# Report on Consultation

## Shin to Loch Buidhe 132 kV OHL Rebuild

January 2026

Figure 2.1: Alignment Options

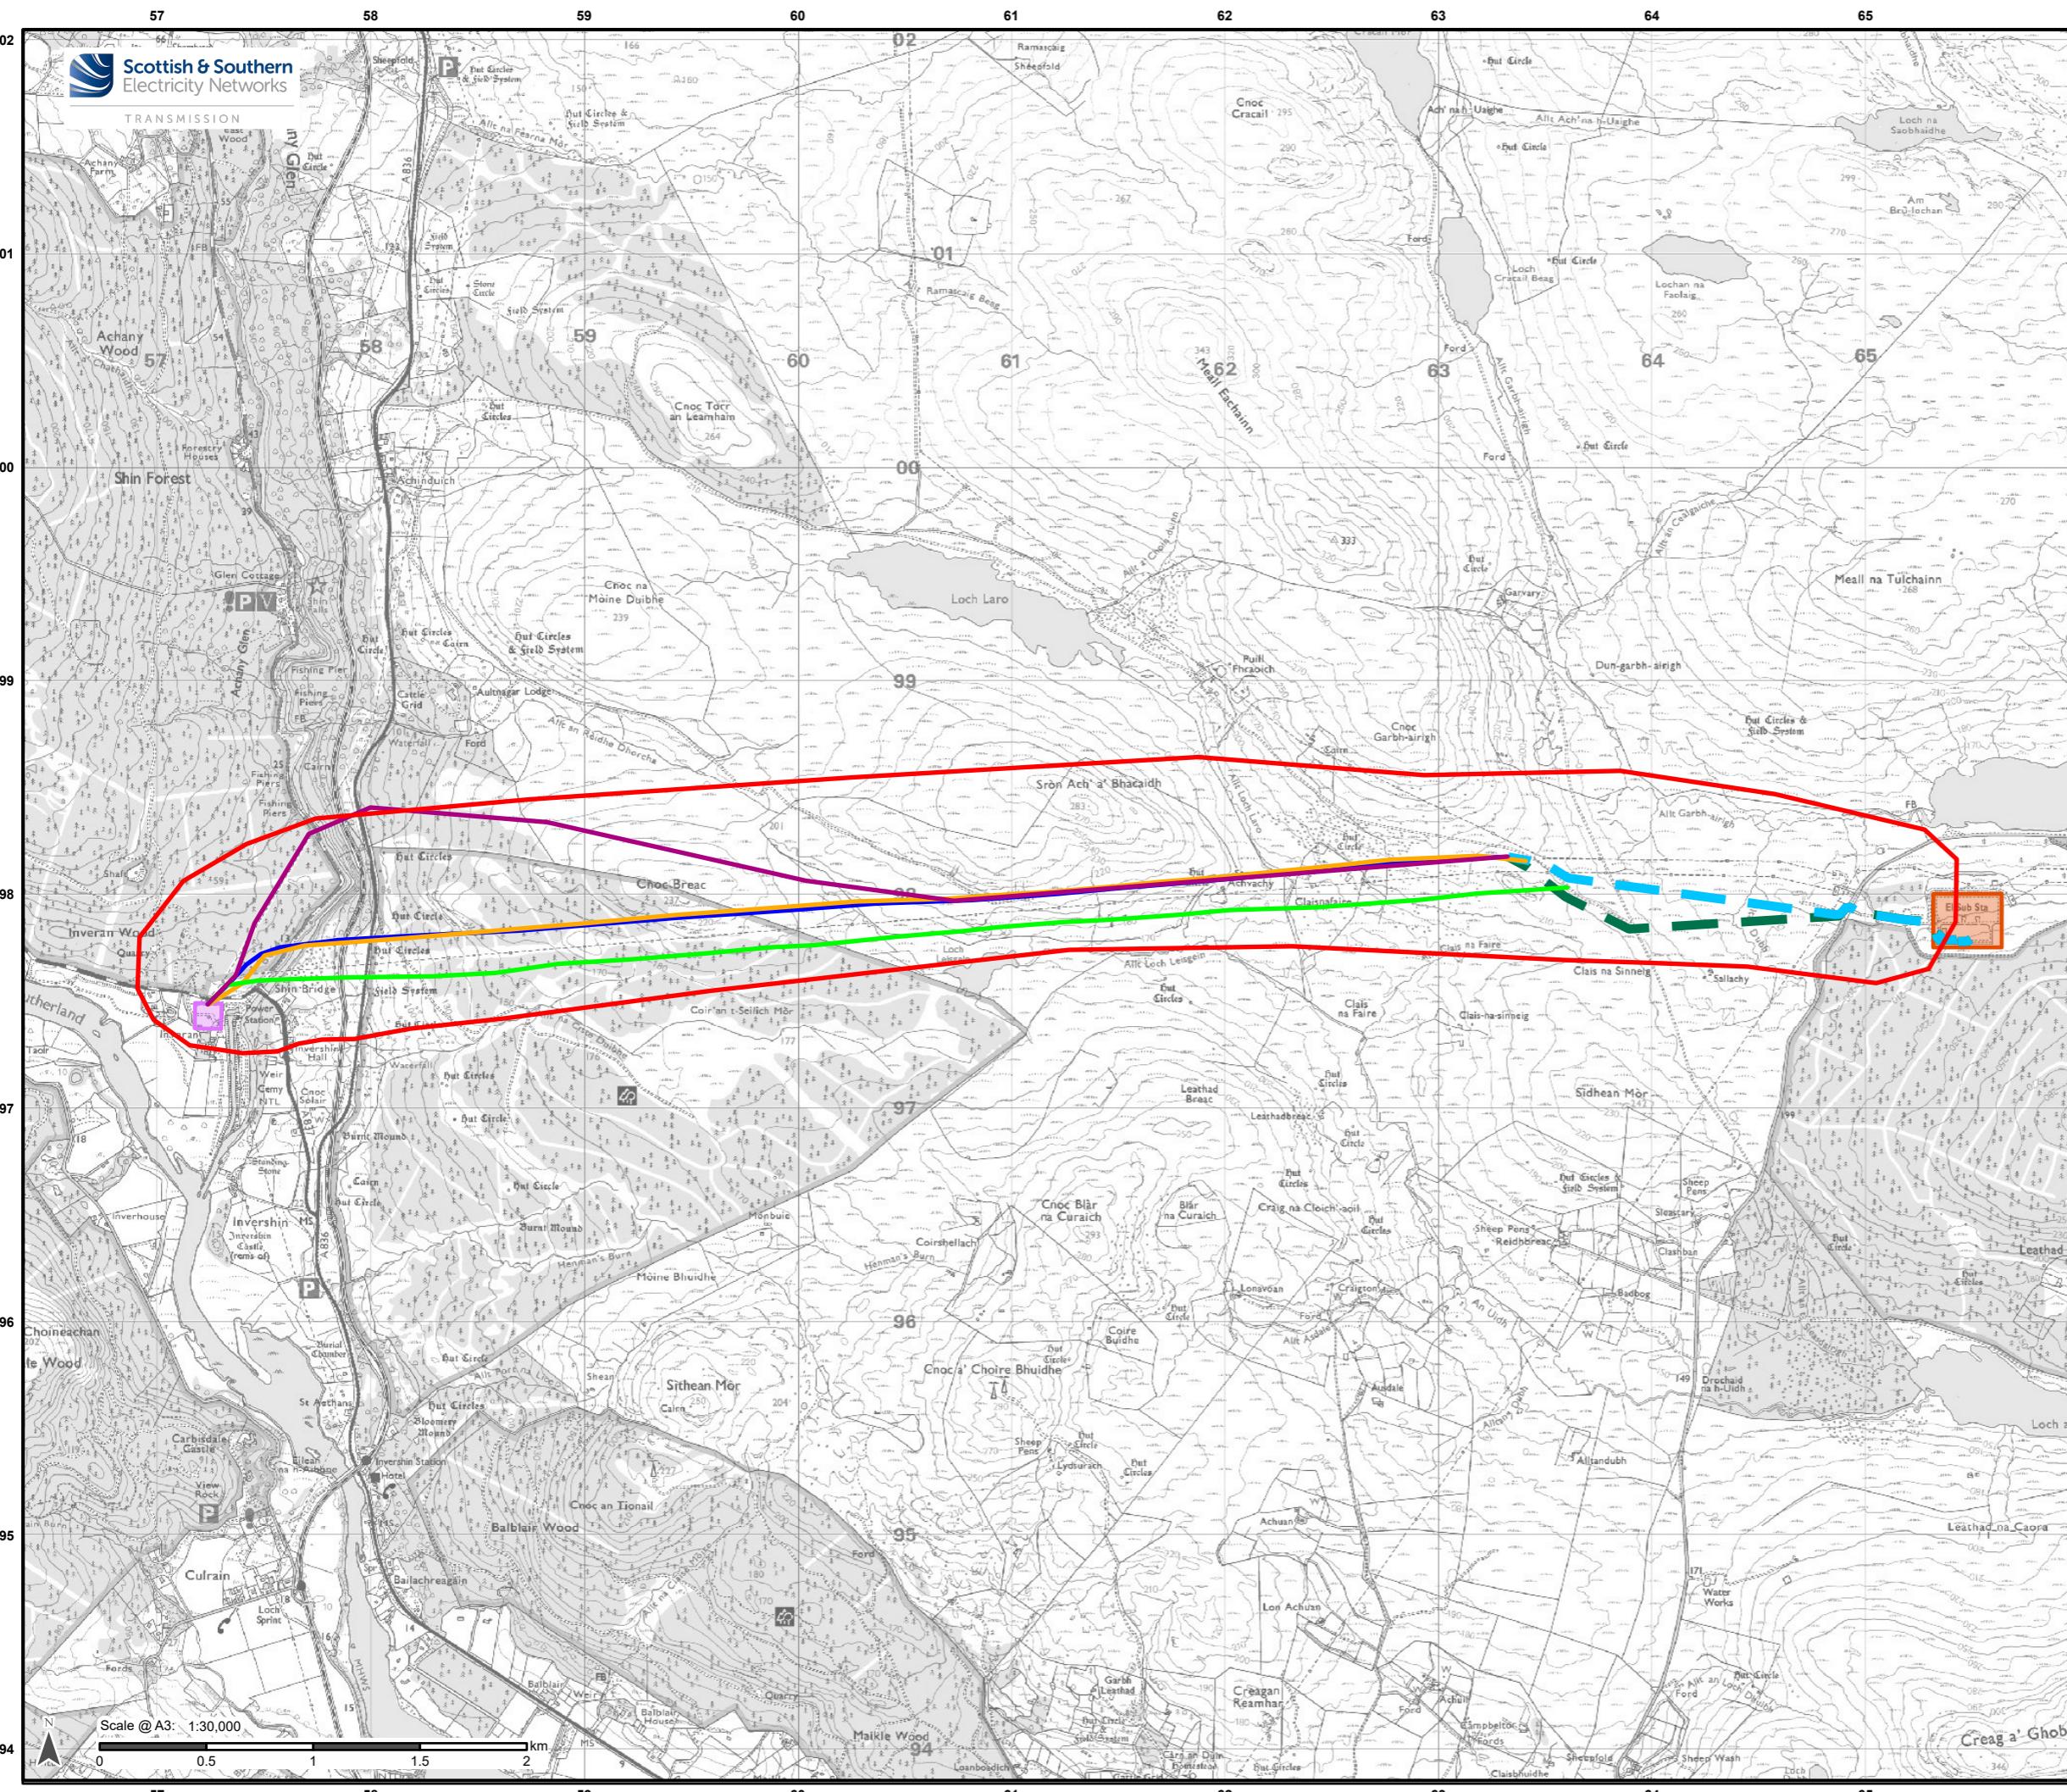
Organisation	Comment	SSEN Transmission Response
<b>Statutory Consultees</b>		
Historic Environment Scotland (HES)	<p><b>Options A1 and A2 are broadly similar, while Option B is the least preferred as it would bisect the scheduled area of Invershin Primary School, settlement 600m E of (SM5498) and likely require the construction of a new pylon within the scheduled area, resulting in unacceptable direct impacts and notable adverse effects on the monument's setting. Option C is the preferred alternative as it avoids direct impacts on scheduled monuments and is not anticipated to generate significant adverse setting effects.</b></p> <p><b>Any works within scheduled areas would require Scheduled Monument Consent, and policy maintains a strong presumption against direct physical impacts.</b></p> <p><b>Should an EIA be undertaken, it must comply with National Planning Framework 4, the Historic Environment Policy for Scotland, and associated guidance. Historic Environment Scotland would welcome the opportunity to comment further as more detailed project information becomes available.</b></p>	<p>SSEN will continue to engage with HES throughout the EIA process. SSEN Transmission have shared design information regarding the Preferred Alignment with HES to inform pre-application engagement.</p> <p>HES have provided their comments on a preferred alignment based on Option A1 provided by the Applicant following the alignment consultation. These comments have been noted, and responses will be provided in the EIA Report.</p> <p>The requirement for Scheduled Monument Consent for works within Scheduled Monuments is noted.</p> <p>The cultural heritage assessment for the EIA will comply with National Planning Framework 4, the Historic Environment Policy for Scotland, and associated guidance.</p>

Scottish Environment Protection Agency (SEPA)	<p><b>SEPA welcomes early engagement on large-scale proposals and provides preliminary advice based on the current stage of development, noting that further information may be requested as the project progresses.</b></p> <p><b>A meeting to discuss key issues is welcomed once peat probing, peat condition assessments, and habitat surveys are completed and the layout is further refined, ideally post-application submission to the Energy Consents Unit.</b></p> <p><b>To avoid delays or objections to the Section 37 application, SEPA requires comprehensive, scaled drawings showing environmental sensitivities (e.g., peat depth, waterbodies, GWDTE) alongside all proposed development elements. A detailed assessment comparing overhead line (OHL) and</b></p>	<p>A meeting will be arranged post-survey completion and layout refinement, following submission to the Energy Consents Unit. However, a pre-application engagement following the surveys will be undertaken to understand any known issues.</p> <p>Scaled drawings showing peat depth, waterbodies, GWDTEs, and all development elements will be included in the Section 37 application.</p> <p>A comparative assessment of OHL and underground cable options was carried out as part of the routeing and alignment assessments that the Consultation Document refers to and will be included within Chapter 3: Site Alternatives of the EIA report.</p>

Kyle Fisheries Organisation	<p><b>It was informed that each of the proposed options appears to present potential risks to watercourses, particularly the Oykel Special Area of Conservation (SAC), making it difficult to determine which route poses the least impact. Therefore, we plan to attend future consultation events and review forthcoming supporting information before providing a formal response.</b></p>	<p>Noted. SSEN will continue to engage with Kyle Fisheries Organisation throughout the EIA process.</p>
RSPB Scotland	<p><b>RSPB Scotland could not provide a detailed response but has submitted general recommendations for consideration. They emphasise the need for a comprehensive desk study and field surveys for breeding and roosting Hen Harrier within 2 km of the proposed alignment, in accordance with NatureScot guidance, as well as for other key bird species such as Merlin, Short-eared Owl, Red Kite, Osprey, and Golden Plover.</b></p>	<p>A desk study and field surveys for Hen Harrier and other key species (Merlin, Short-eared Owl, Red Kite, Osprey, Golden Plover) has been undertaken in accordance with NatureScot guidance.</p> <p>One year of flight activity surveys has been completed to assess collision risk.</p>
